Committee of the Whole Report

For the Meeting of September 14, 2023

Subject: Rezoning Application No. 00806 and associated Development Permit with Variances Application No. 00193 for 1702 Quadra Street/862 Fisgard Street

Figure 3 – 90m radius from 1701 Quadra Street (First Metropolitan United Church)

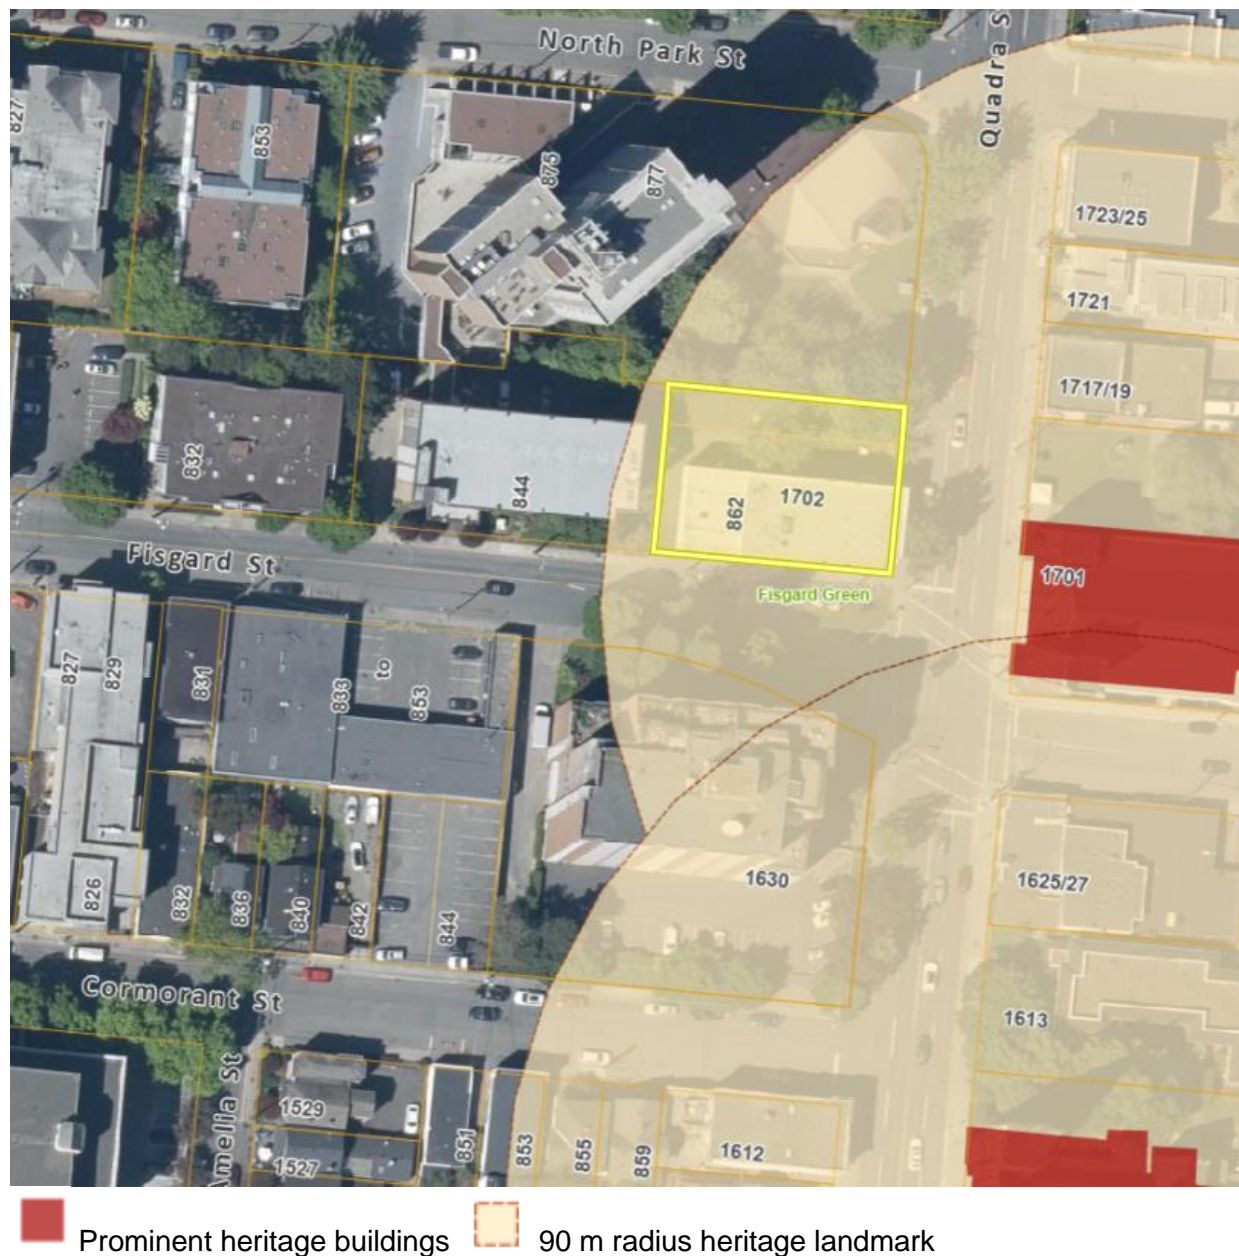
The subject property is within a 90m heritage landmark radius from the heritage designated First Metropolitan United Church at 1701 Quadra Street and is just beyond the landmark radius of St. John the Divine Anglican Church at 1611 Quadra Street. Both buildings are listed as prominent heritage buildings in the OCP. *Official Community Plan* policy indicates that the views of these landmark buildings from the public realm should be given careful consideration when new development is proposed within the identified radius. The entire subject property is within the landmark radius of 1701 Quadra Street (see figure 3); therefore, locating the tower outside of the landmark building radius is not an option. However, staff are concerned that the tower design has not adequately contemplated the view of the heritage property from the public realm, or the prominence of the proposed building in this section of Church Row.

Downtown Core Area Plan guidelines call for a minimum 10m setback from adjacent rear and side setbacks, which is not achieved with this proposal. There is limited, if any, opportunity to relocate the tower on the subject property, nor would relocation have a substantial impact on the relationship with the adjacent heritage property.

The proposed material and colour of the building appear to create a significant contrast between the proposed building and the surrounding heritage landmark buildings. According to the application brief, the intention with the selection of materials and colour was to be “*respectful to the surrounding heritage structures and neighbourhood history...grounded in context but contemporary in appearance.*” Some of the material choices are intended to reduce visual impact and provide a sense of lightness.

Design rationale notwithstanding, there are concerns that the tower may not be responding to the surrounding context in colour and material choice, nor be well integrated within the context of the adjacent heritage brick buildings. Staff are concerned that the material and colour choices will have the opposite effect of what is intended and have a dominating effect on the surrounding heritage buildings due to the contrast and reflective quality of the proposed metal panels.

Should Council choose to advance this application, the recommendation includes appropriate language for staff to work with the applicant to refine the material palette and improve the compatibility of the proposal within the heritage context of “Church Row”. If Council does not want to require refinement to the materials, an alternative option to proceed with the proposed material treatment is provided.
